Road Changes Prompted by 2018 Mileage Certificates

Vermont Agency of Transportation

Friday, April 27, 2018

Mileage Certificate Change 2018 NORTH BENNINGTON VILLAGE

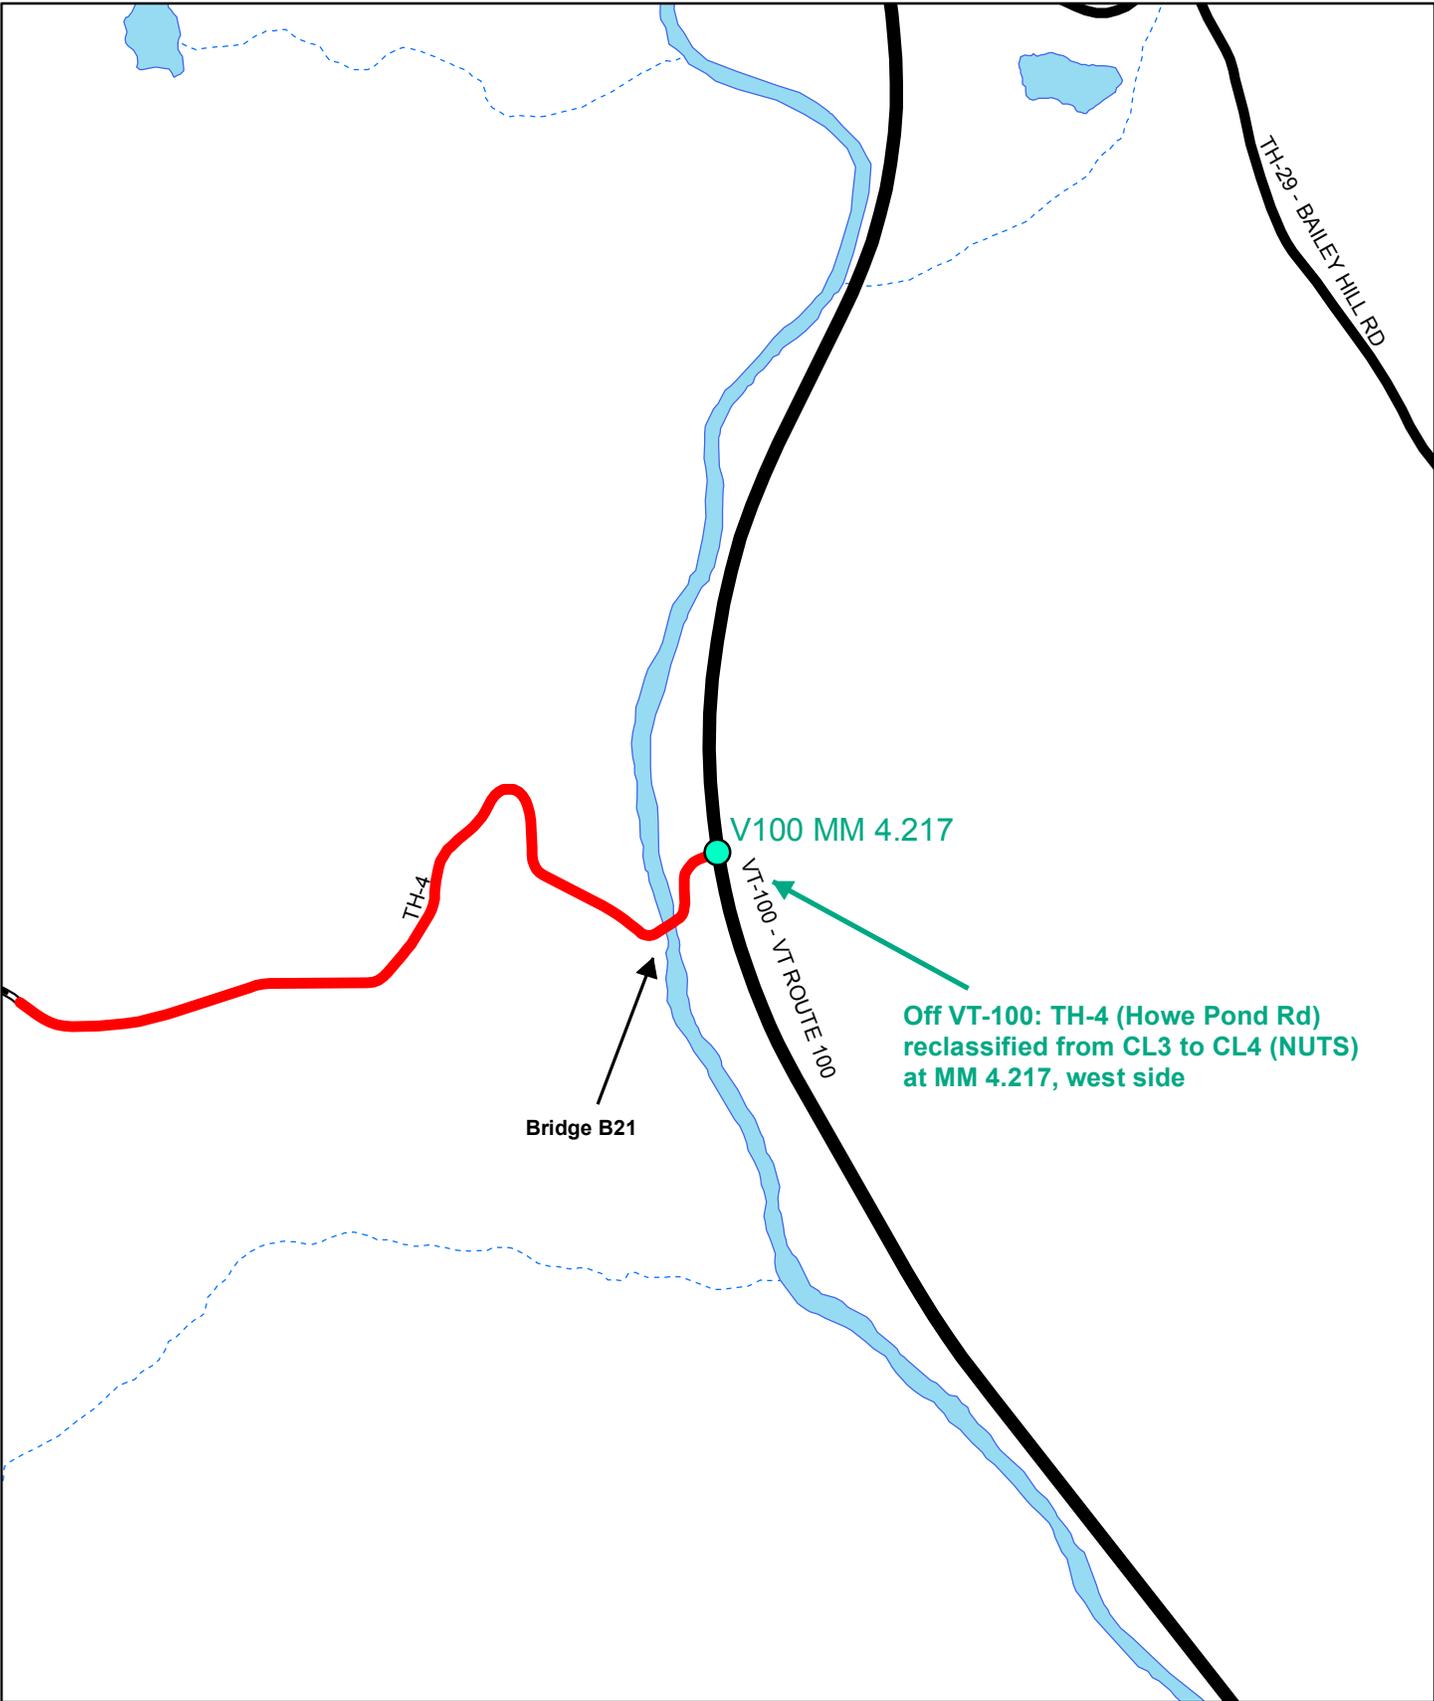
Along VT-67:
mileage adjustment due to
remeasurement of route
from MM 0.460 to MM 0.679

Note: End-to-end mileages have not yet
been updated for the remainder of VT-67
as it runs through Shaftsbury (CTCODE
0213), and should be increased by
0.015mi at each point beginning at ETE
MM 2.224. Town mileages for Shaftsbury
do not need updates.

Along VT-67A:
mileage adjustment due to
remeasurement of route
from MM 3.226 to MM 3.341

**Mileage Certificate Changes 2018
DANVILLE (0303-0)**

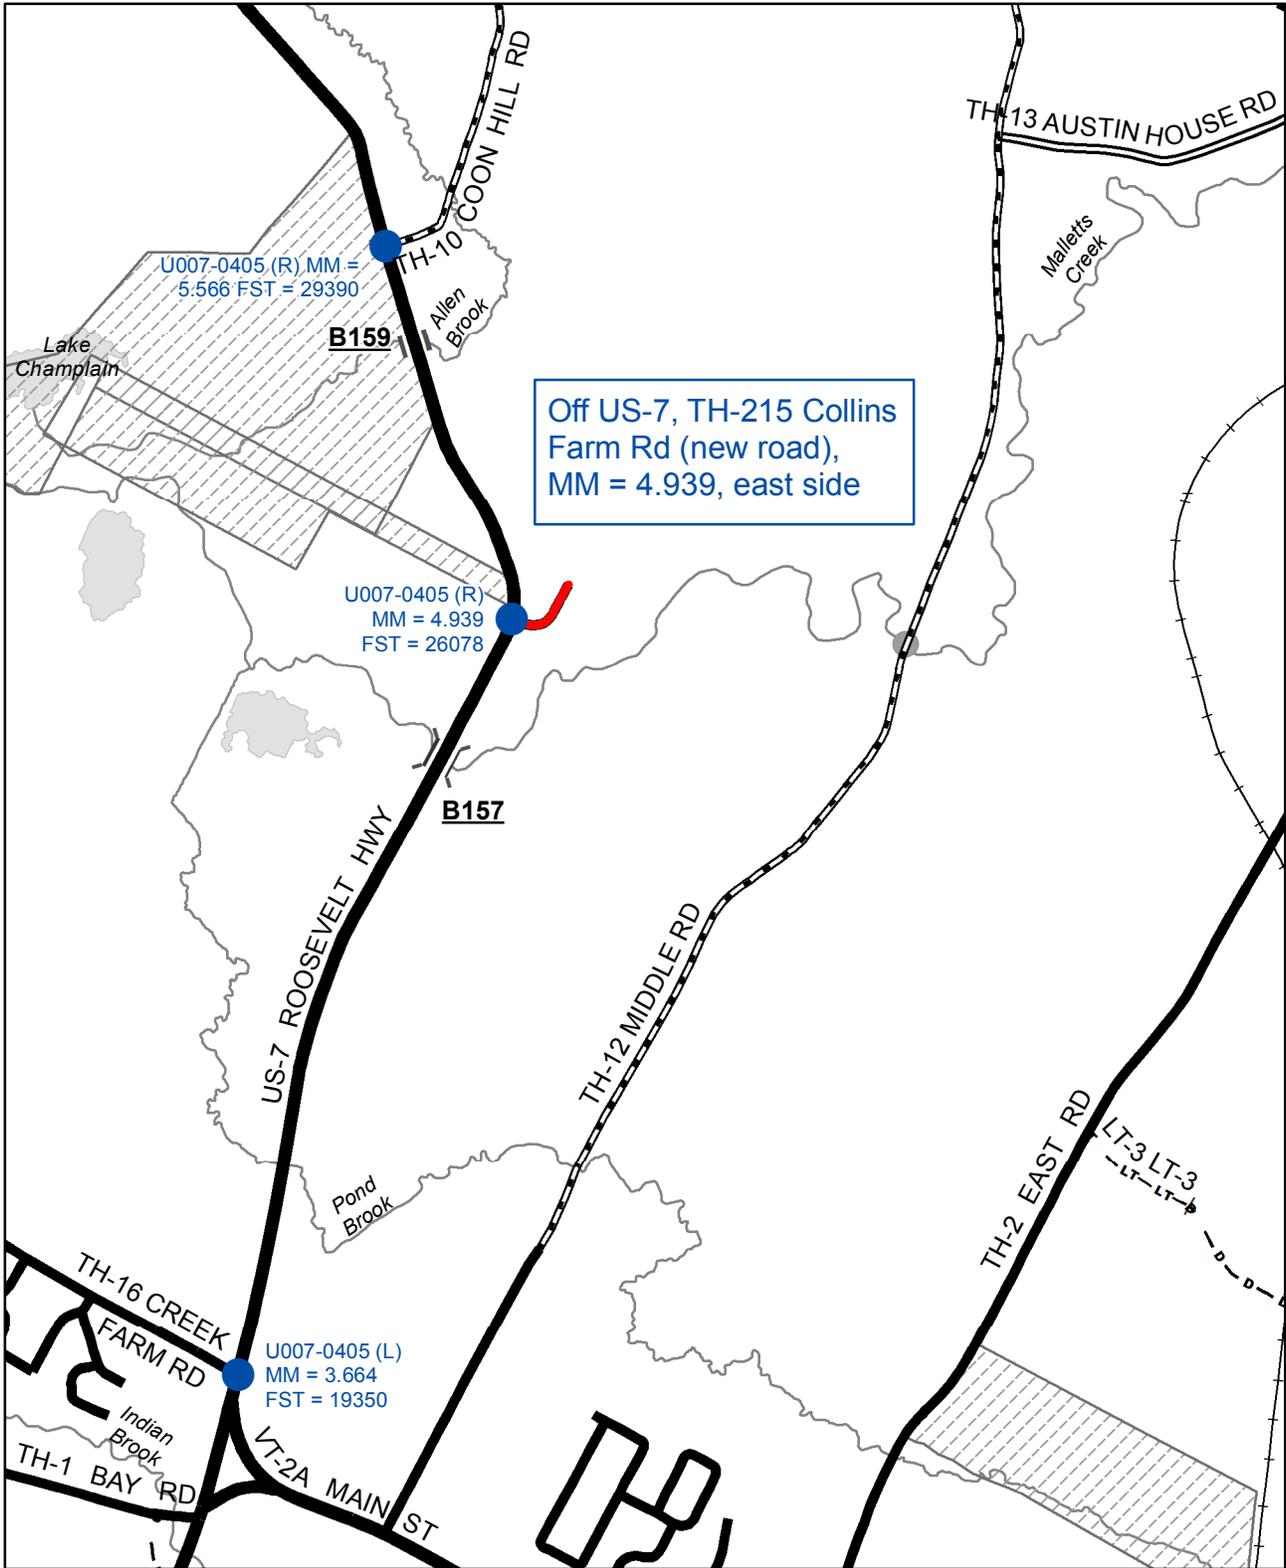
Off US-2, TH-134 (Church St) new road, MM = 4.703, south side

Mileage Certificate Changes 2018
RICHMOND
 (0411-0)

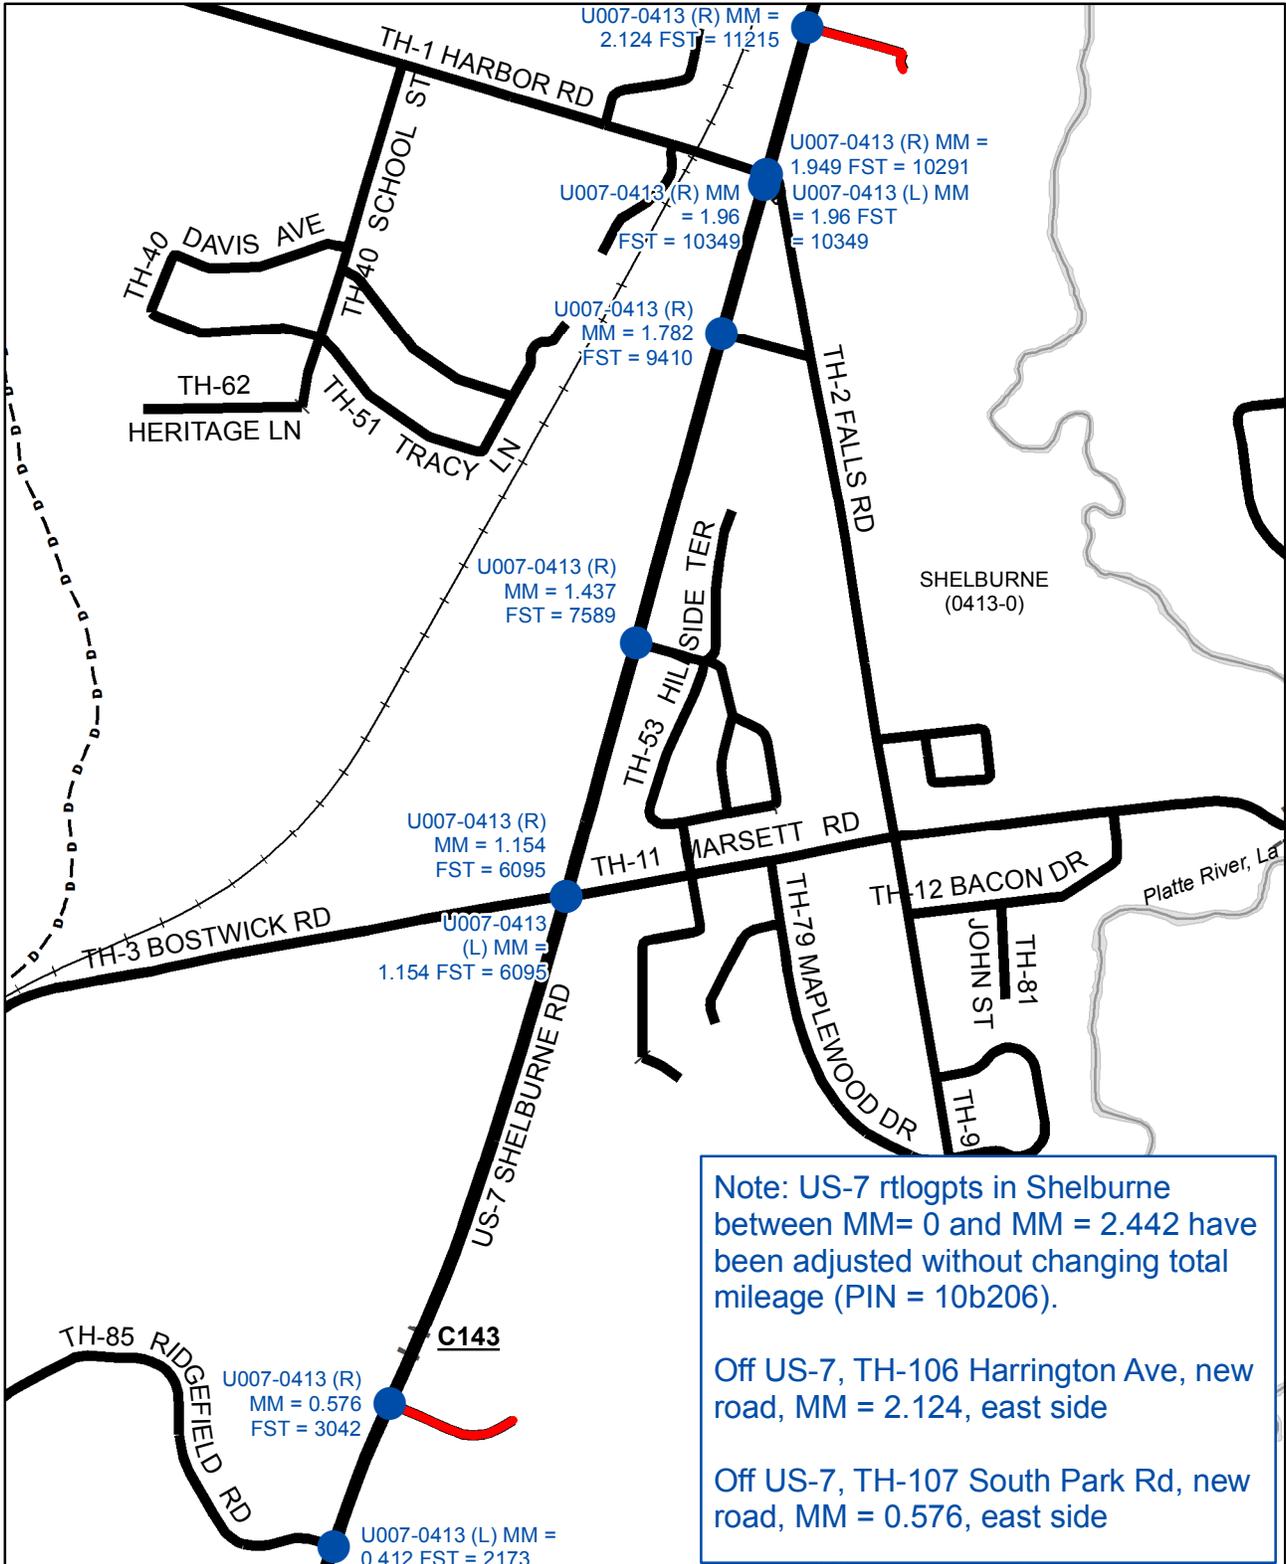
CL3 TH-16 (Johnnie Brook Rd) no longer intersects US-2, was at MM = 0.647 south side (Now intersects Kenyon Rd, off US-2 @ MM = 0.628)

+0.04 mi CL3 TH-16 (Johnnie Brook Rd) realigned at US-2 and Kenyon Rd

-0.02 mi CL3 TH-16 (Johnnie Brook Rd) remeasured to end of CL3

Mileage Certificate Change 2018
BROOKFIELD
 (CTUA: 0903-0)

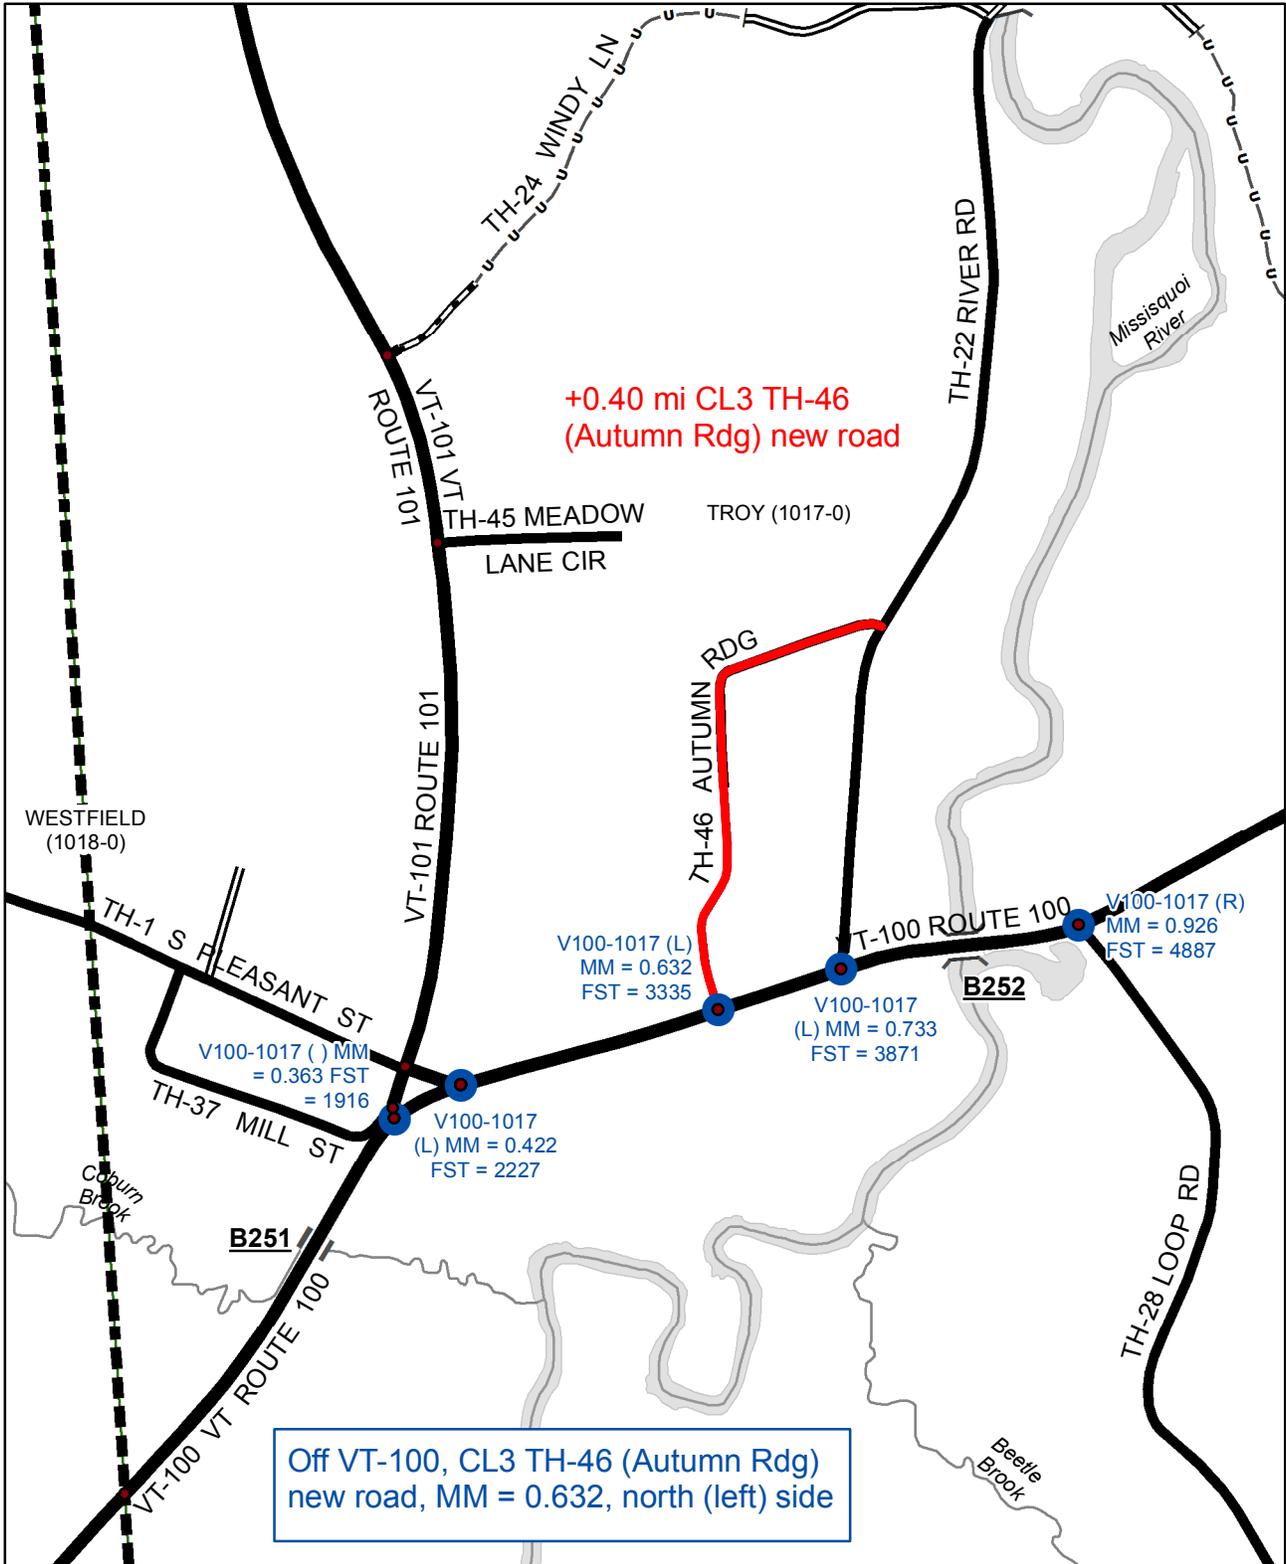
Off VT-65: TH-3 (West St)
 approach mileage not previously accounted for
 at MM 2.41, south side

V065 MM 2.41
